**STAFF REPORT
PLANNING MANAGER DECISION**

DATE: August 7, 2023
FILE NO.: HDR-23-01
REQUEST: Approval of a Class I Historic Design Review at 1296 12th St
PLANNER: Ben Gardner, Assistant Planner

**ADDENDUM
APPROVAL CRITERIA AND FINDINGS
HDR-23-01**

REAR ELEVATION

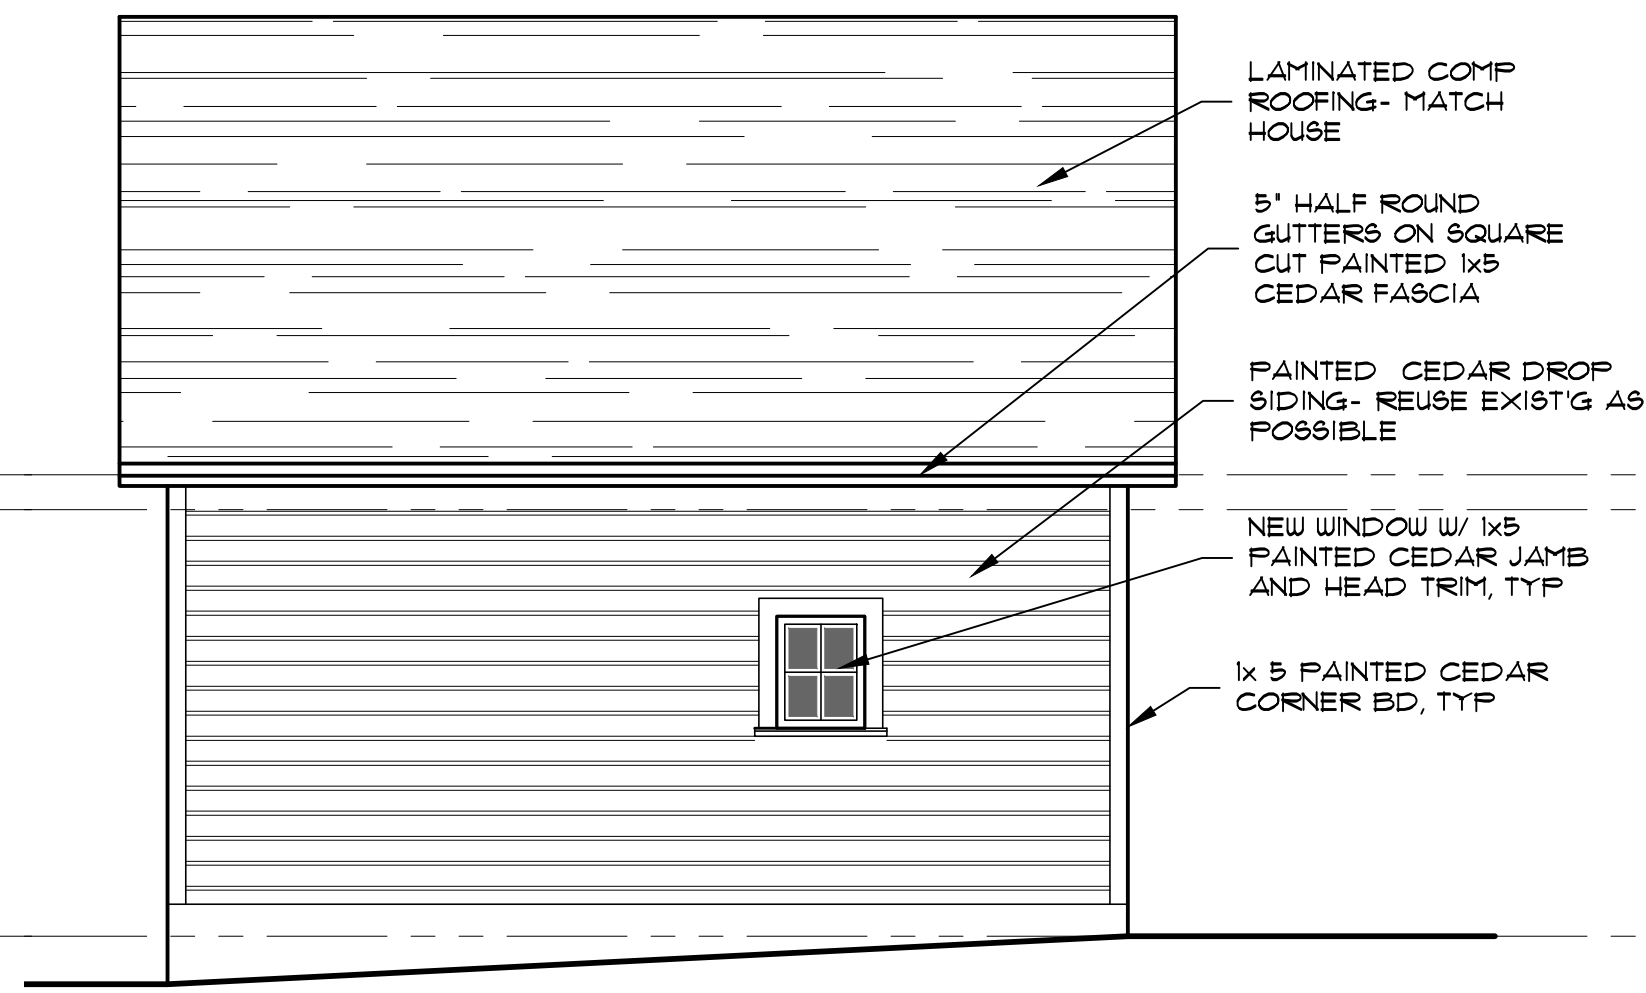
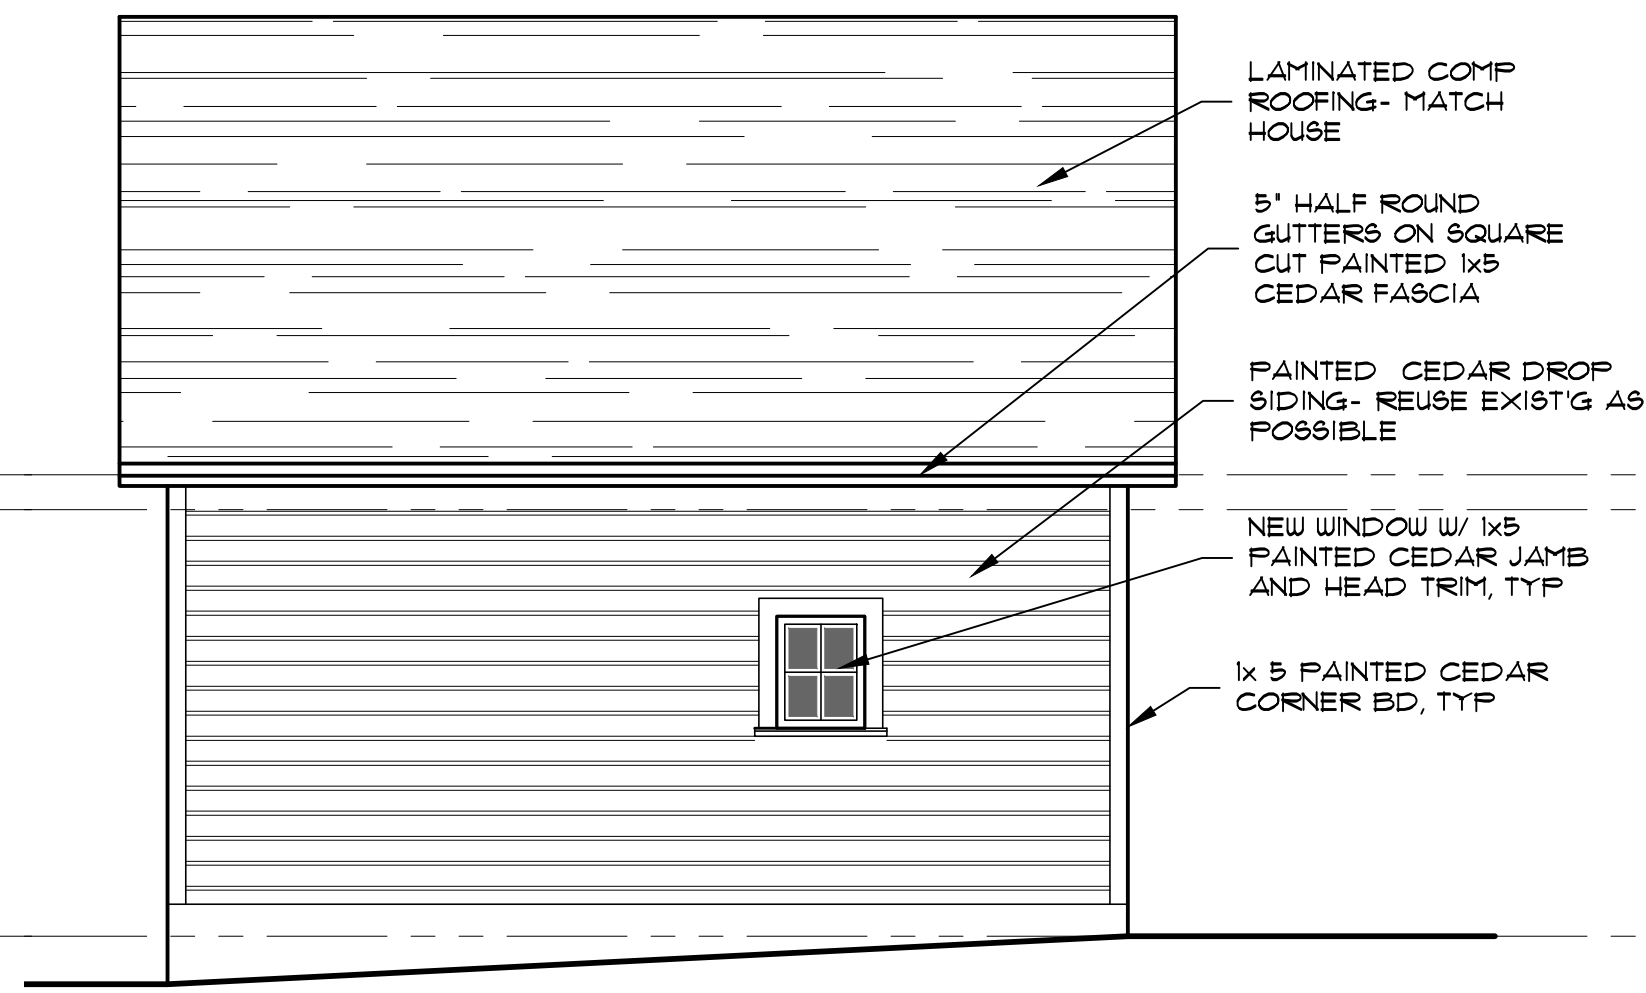
Rear Facing Façade – New window proposed to be located left of the door shown on the right.

Staff Finding 10: Staff adopts the Applicant findings for these criteria as contained in page 4 of Exhibit PD-1. The Applicant proposes to install a new window on the rear-facing façade of the structure. The window will match the appearance and size of the original windows and will be made of wood. No replacement of existing windows is proposed. The criteria are met.

Applicant Response: *“New window on South wall will be on rear façade of accessory structure and not visible from street. New window will match the appearance and size of existing windows exactly. Frame and sash will be made of wood.”*

LEFT SIDE ELEVATION

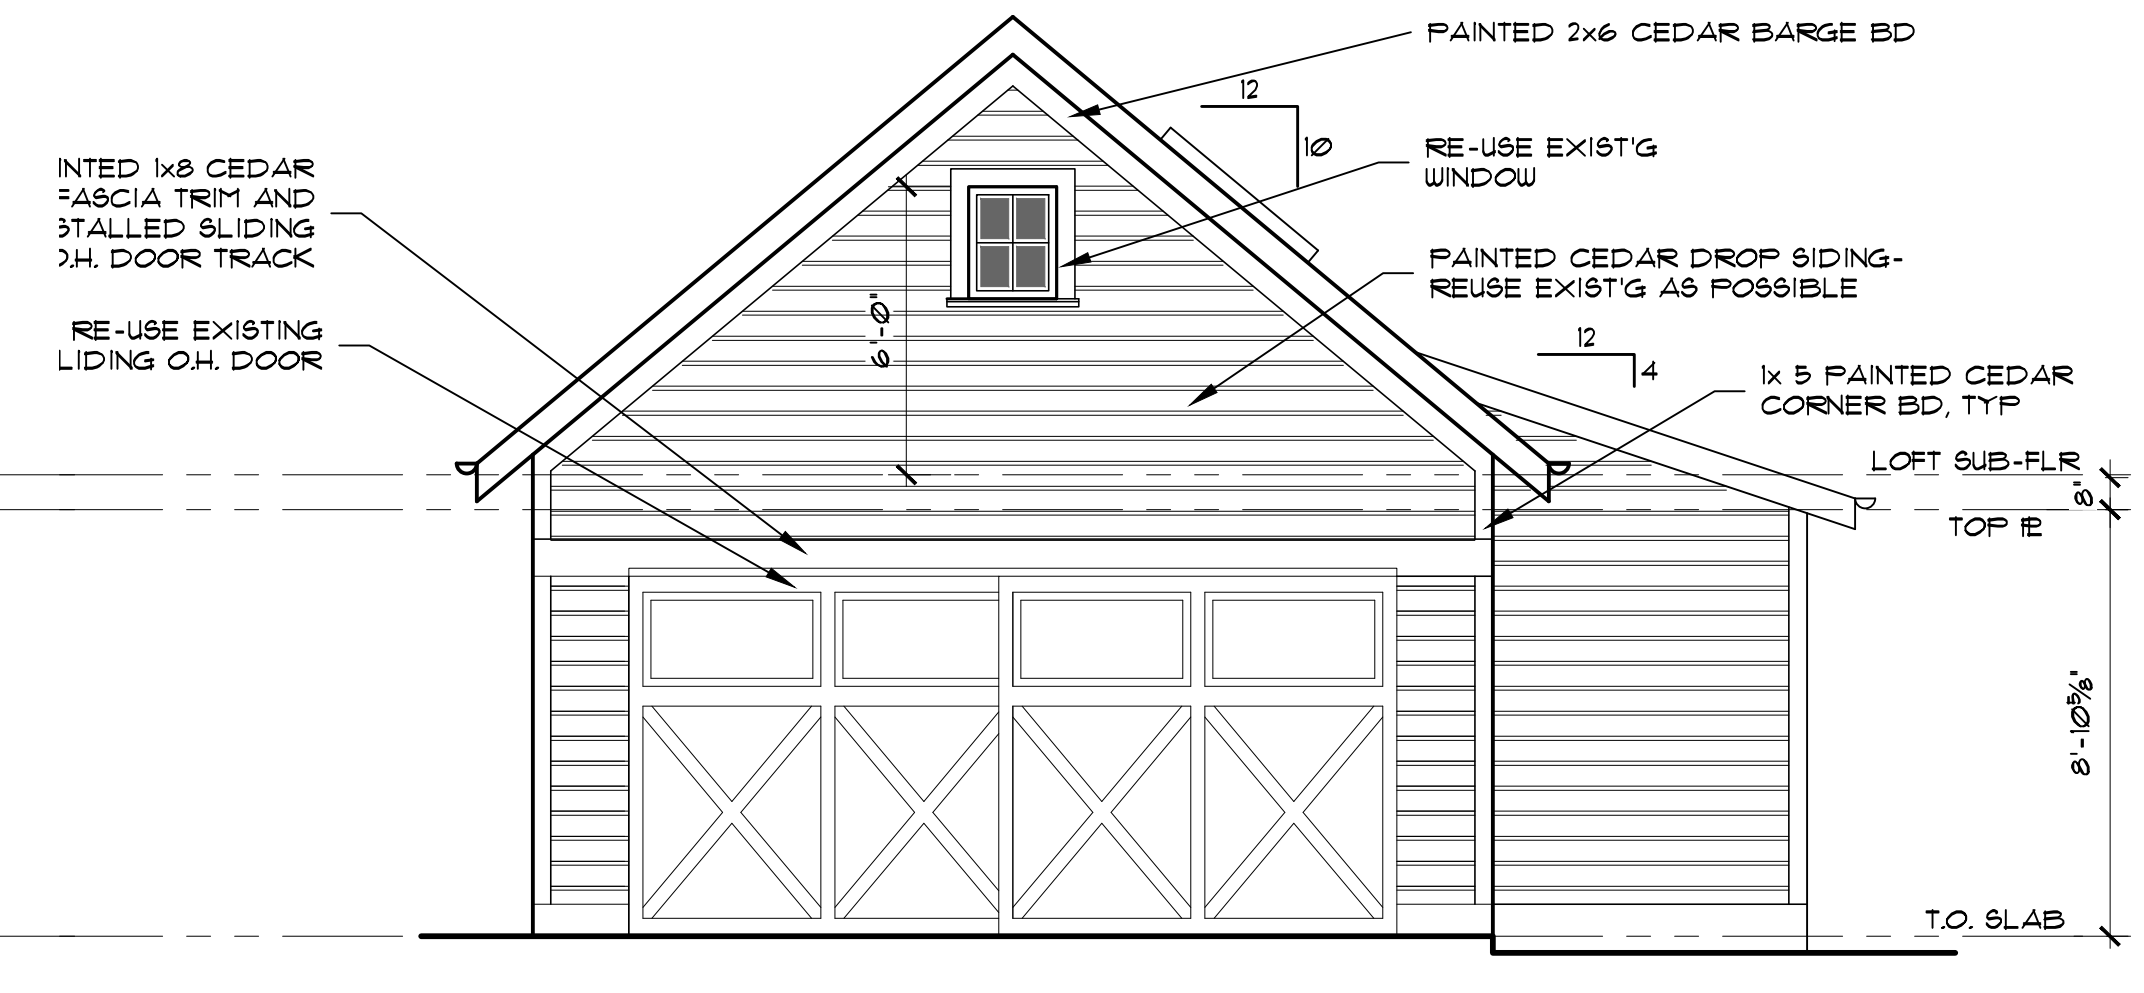
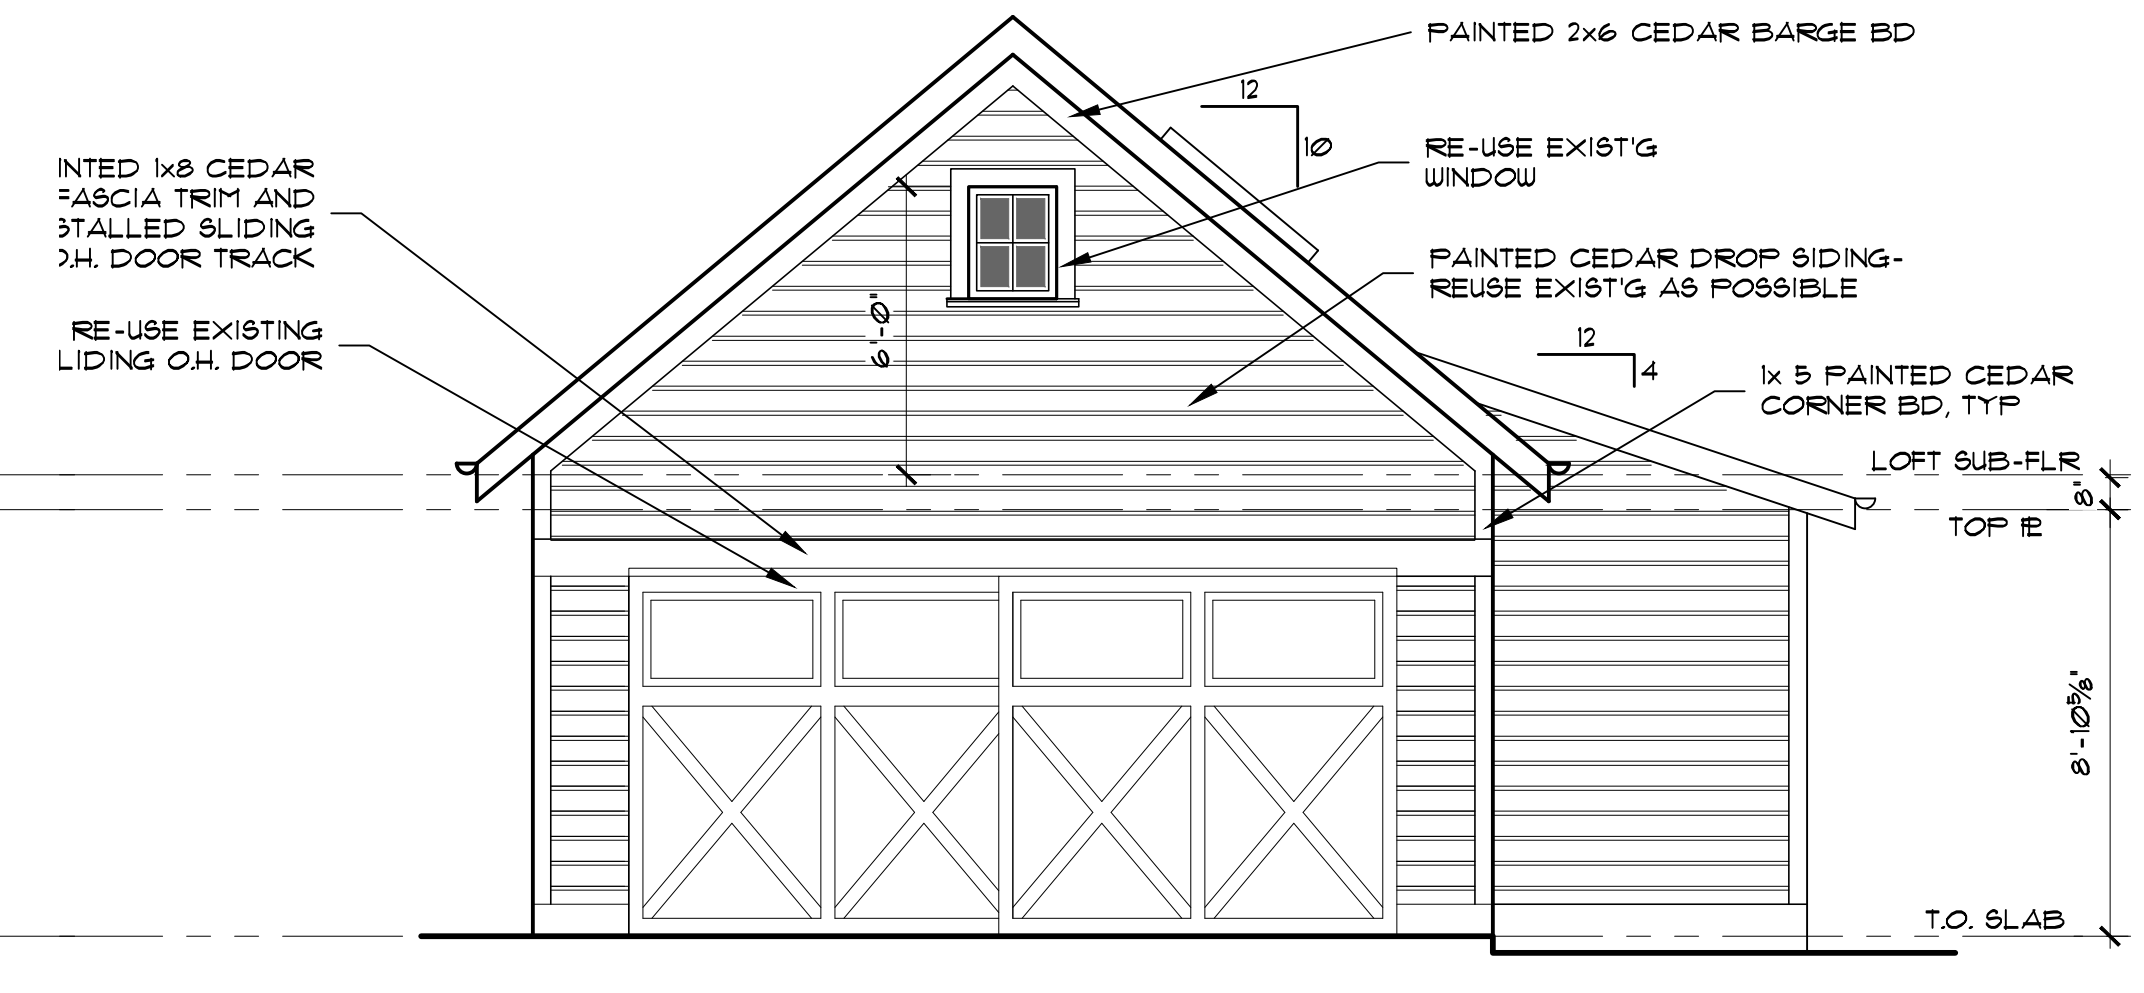
Side Facing façade – Door shown on right to be filled in with matching siding.

Staff Finding 8: The Applicant proposes filling in one of the existing side doors with wood siding that matches the existing siding. The criteria are met.

Applicant Response: “West-facing door will be replaced by siding matching the siding on the rest of the structure. New south-facing window will match the other windows on the structure in all respects.”
